PERCOLATION TESTING

SUBDIVISION Cissel Property LOT NO 11

Lot #10 Spring Hollow Development
Plate # 10938
42,061 sqft.

Description of Revision

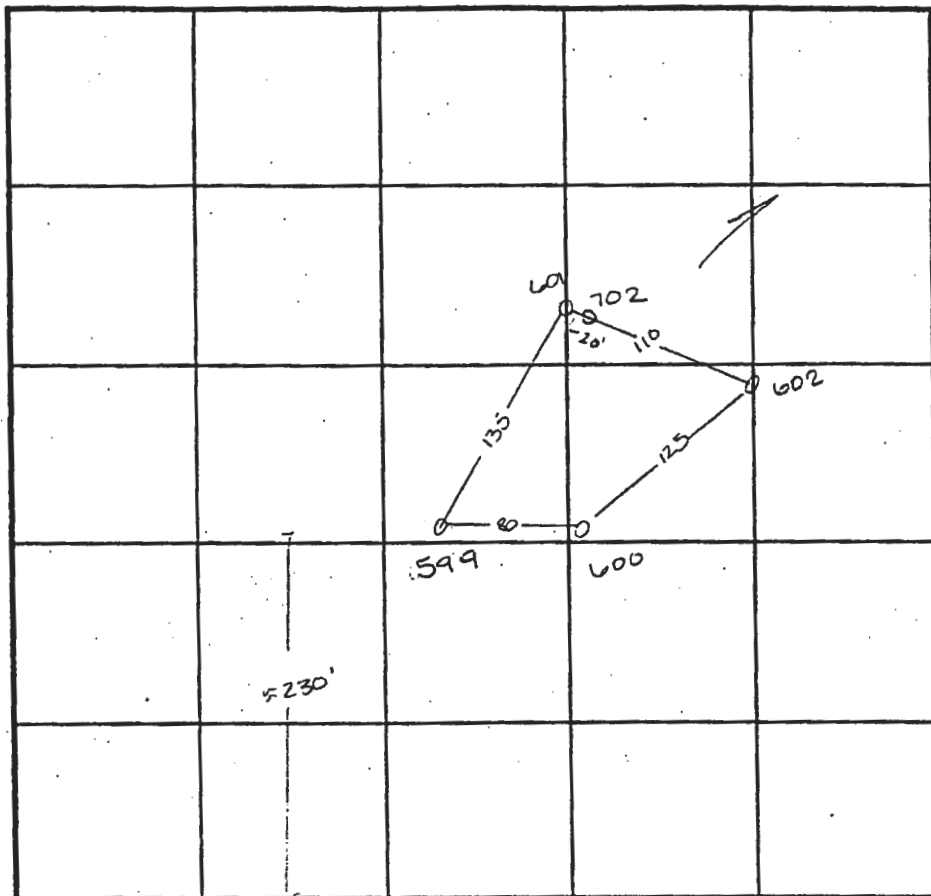
By adding 5' to both sides, this adds about ~1000' square feet to the Septic Reserve Field. A portion of the 1000 square feet (~800) is used to reshape the reserve field as to allow for the required 20 foot setback from the proposed pool.
